Access Compliance Report Public Rights-of-Way (Pedestrian Signals)

Intersection ID: N/A	Main Street:	Cross Street: N/A	Location: N/A
ADA ID: C57597DF3369	Signal Type: One Push Button-Non APS	Overall Compliance: No	Severity Score: BTN 1: N/A BTN 2: N/A No BTN: N/A
Codes/Mitigation Info/Possible Solution		Field Measurements/Component Compliance

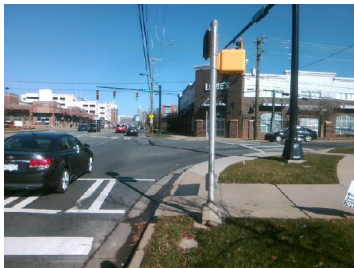
PROW/ADA: R404.3, R404.2

Compliance	Description	Data	Compliance	Description	Data
	Button Count	Button1	N/A	Distant to Additional Button (in)	N/A
	Additional Button Present?	No		Additional Button ID	N/A
N/A	Signal Buttons Required?	N/A	N/A	Additional Ped Posts Required	N/A
	How Many Ped Street Xings?	2		Located In An Island/Median?	No
N/A	B 1 Sign Present?	Yes	N/A	B 2 Sign Present?	N/A
Yes	B 1 Sign Purpose?	Yes	N/A	B 2 Sign Purpose?	N/A
Yes	B 1 Sign Lettering & Contrast?	Yes	N/A	B 2 Sign Lettering & Contrast?	N/A
Yes	B 1 Parallel To XWalk?	Yes	N/A	B 2 Parallel To XWalk?	N/A
No	B 1 PAR to Button?	No	N/A	B 2 PAR to Button?	N/A
No	B 1 PAR to XWalk?	No	N/A	B 2 PAR to XWalk?	N/A
Yes	B 1 Clear Floor Space?	Yes	N/A	B 2 Clear Floor Space?	N/A
N/A	B 1 FWD Approach?	Yes	N/A	B 2 FWD Approach?	N/A
N/A	B 1 FWD Approach Constrained?	No	N/A	B 2 FWD Approach Constrained?	N/A
Yes	B 1 FWD Approach Reach (in)	0.0	N/A	B 2 FWD Approach Reach (in)	N/A

N/A	B 1 FWD Approach Width (in)	N/A	N/A	B 2 FWD Approach Width (in)	N/A
N/A	B 1 FWD Approach Obstruction?	Yes	N/A	B 2 FWD Approach Obstruction?	N/A
N/A	B 1 FWD Approach Obstruction Dist (in)	0.0	N/A	B 2 FWD Approach ObstructionDist (in)	N/A
N/A	B 1 PARA Approach?	Yes	N/A	B 2 PARA Approach?	N/A
N/A	B 1 PARA Approach Constrained?	No	N/A	B 2 PARA Approach Constrained?	N/A
Yes	B 1 PARA Approach Reach (in)	0.0	N/A	B 2 PARA Approach Reach (in)	N/A
N/A	B 1 PARA Approach Width (in)	N/A	N/A	B 2 PARA Approach Width (in)	N/A
N/A	B 1 PARA Approach Obstruction?	Yes	N/A	B 2 PARA Approach Obstruction?	N/A
N/A	B 1 PARA Approach Obstruction Dist (in)	0.0	N/A	B 2 PARA Approach ObstructionDist (in)	N/A
No	B 1 Clear Floor Space Slope (%)	3.5	N/A	B 2 Clear Floor Space Slope (%)	N/A
Yes	B 1 Clear Floor Space XSlope (%)	0.2	N/A	B 2 Clear Floor Space XSlope (%)	N/A
N/A	B 1 PAR Slope (%)	2.1	N/A	B 2 PAR Slope (%)	N/A
Yes	B 1 Height (in)	36.0	N/A	B 2 Height (in)	N/A

Possible Solutions: Provide PAR As Indicated. Remove and Replace Clear Space.
